Docket No. 50-346

By letter dated July 14, 1983 (Serial No. 972), Toledo Edison submitted to the Nuclear Regulatory Commission (NRC) a request for approval for the alternative on-site disposal of very-low-level radioactively contaminated secondary-side clean-up resins. This request was made pursuant to the regulation of 10 CFR 20.302.

Your letter of May 4, 1984 (Log No. 1509) requested additional information to support Toledo Edison's request for approval to dispose on-site certain very low level radioactivity contaminated wastes. Attachment 1 provides the requested information.

ADDITIONAL INFORMATION TO TOLEDO EDISON'S  
SUBMITTAL CONCERNING ON-SITE DISPOSAL OF RESIN

Figure 1  
Davis-Besse Site Area Map

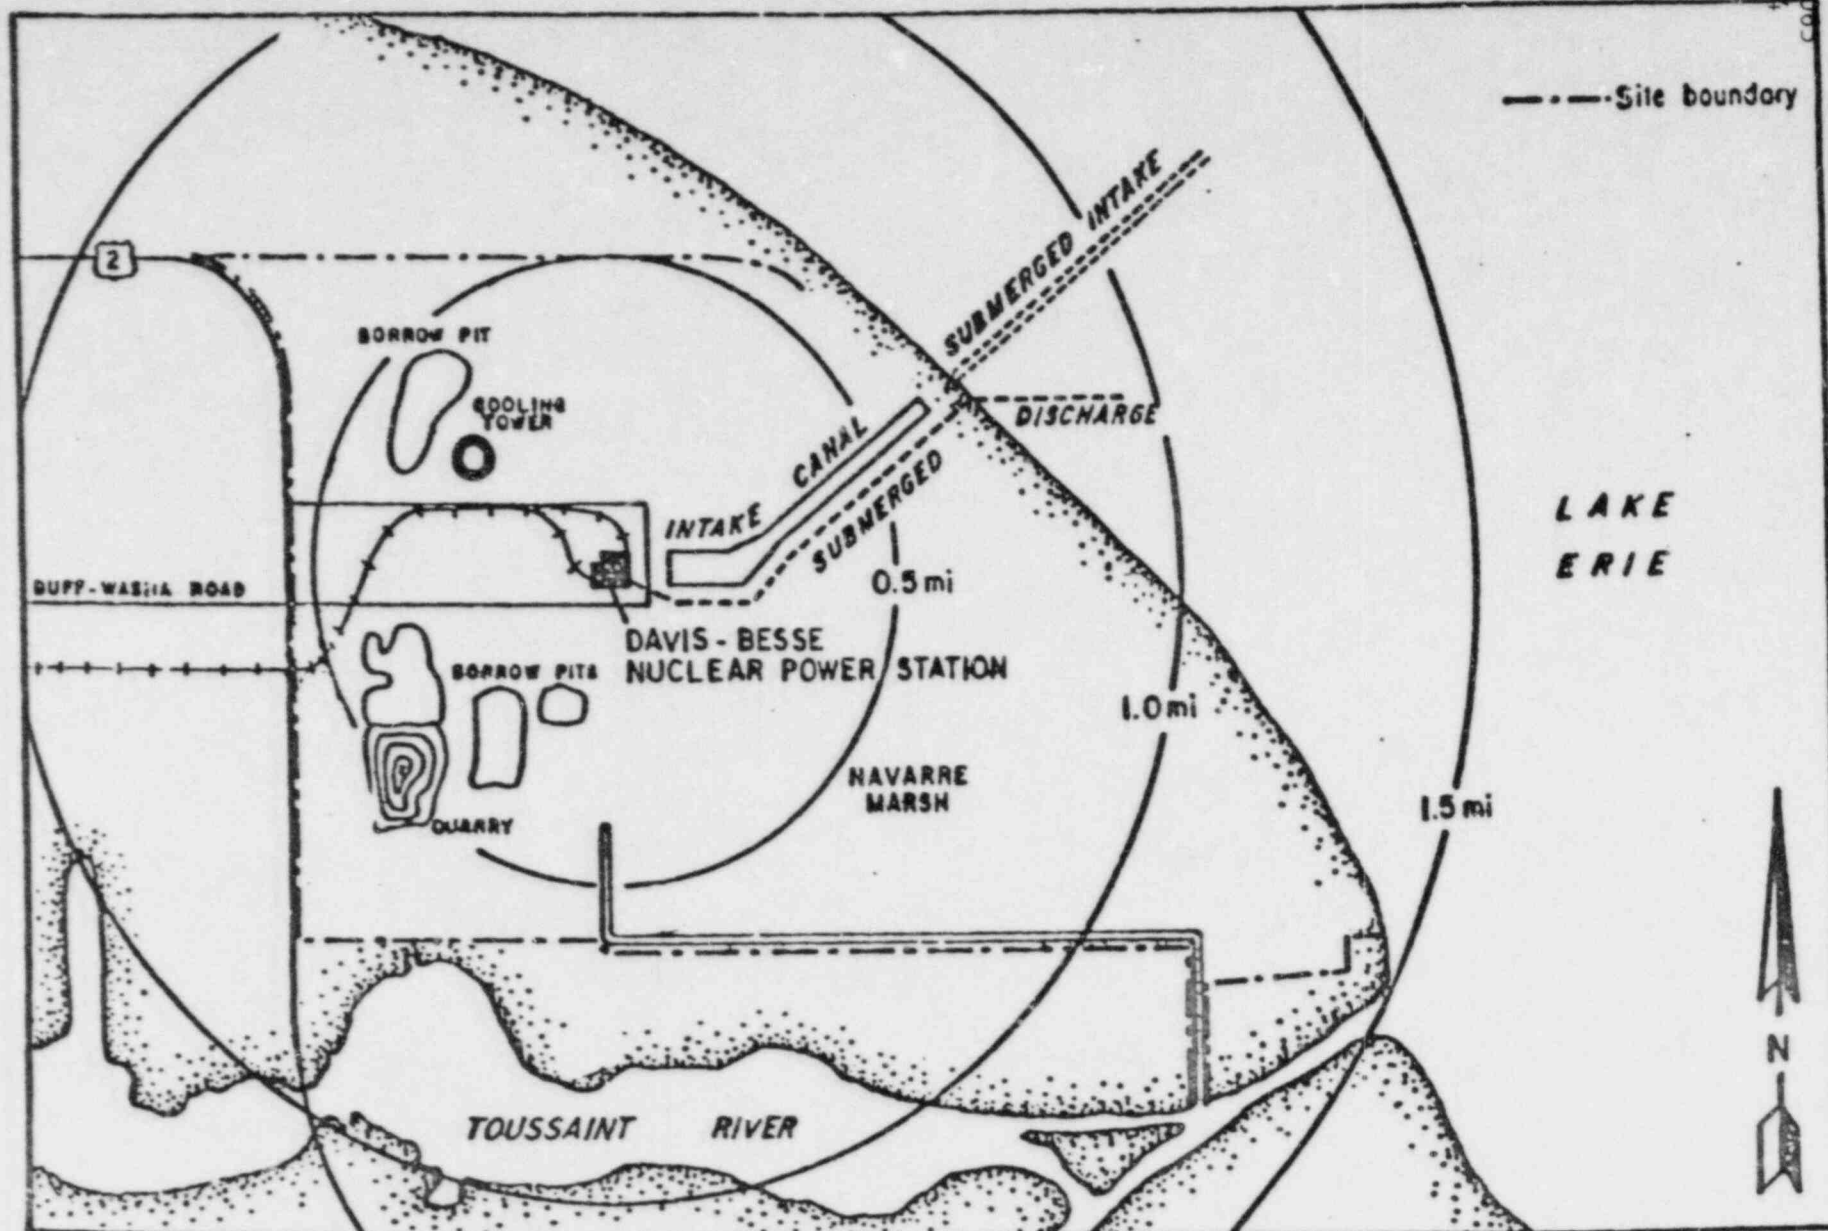
Question 4: Describe the planned disposal site for the dredged material. For the planned on-site disposal, the disposal site description should include (1) a numbered and captioned figure of the disposal site showing its proximity to areas frequently occupied by workers, and to the unrestricted area; (2) the area of the disposal site, and the planned thickness of the disposed material; (3) a description of any physical barriers or administrative procedures that would be used to reduce exposure of workers or the general public; (4) the type of and thickness of any covering material that will be placed over the dredged material to reduce exposure; and (5) the time frame in which any covering will be placed over the dredged material.

Response: While the specific on-site location for the actual disposal of the dredged basin bottoms remains to be identified, the following particulars of the site selection and disposal method are applicable:

- The Davis-Besse site contains approximately 954 acres. There exist numerous on-site locations that are remote from frequently occupied areas and that are acceptable for use as a final disposal area for the dredged basin bottoms. The selected disposal site will be a minimum of 100 yards from any area frequently occupied, either on-site or off-site. The attached site area map (Figure 1) indicates the general characteristics of the Davis-Besse site.

The need of additional physical barriers for limiting access (and resulting exposure) to the disposed basin bottoms is not anticipated at this time. Though access to the site is not totally restricted, the existing site boundary fencing and surrounding environmental characteristics (i.e. Navarre Marsh in the southeast sector of the site) provide restricted access; no uncontrolled areas on-site are frequented by members of the public.
